### **Lexington Planning Board**

Re: Project Review for 287-295 Waltham Street: SRD, Major Site Plan Review | Memo 4

Lexington Planning Board c/o Abby McCabe, AICP Planning Director 1625 Massachusetts Avenue Lexington, MA 02420 RE: Nitsch Project #15854.4 Third Review Letter 287 & 295 Waltham Street Lexington, MA

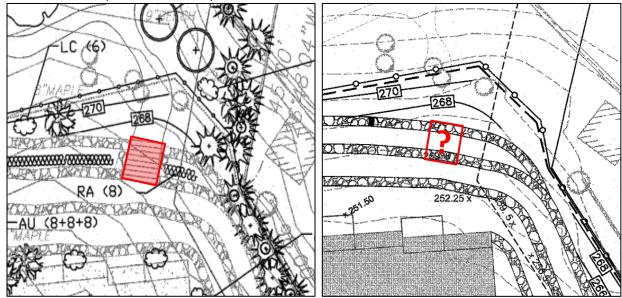
The LOW line does not extend to the walking path behind Building C, but the path is still referenced in plans.

Where is access for the walking path behind Building C provided? The landscaping plan shows a set of stairs that aren't present on other plans.

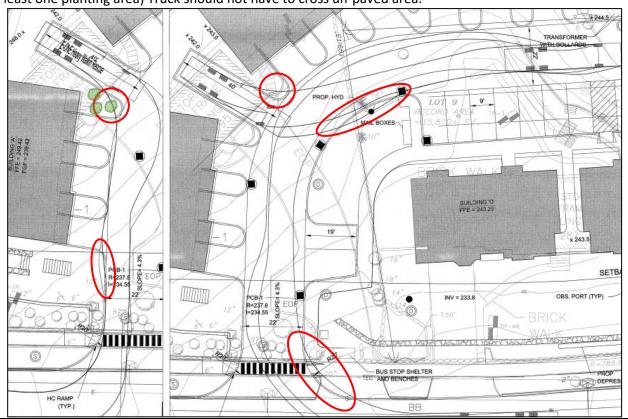
Please show that the rear of any of the buildings is reachable by 250 ft. of hose from both sides and meeting for fire department confirmation.

Plans show the truck having to cross over non-paved areas to negotiate the turnaround (conflict with at least one planting area) Truck should not have to cross un-paved area.
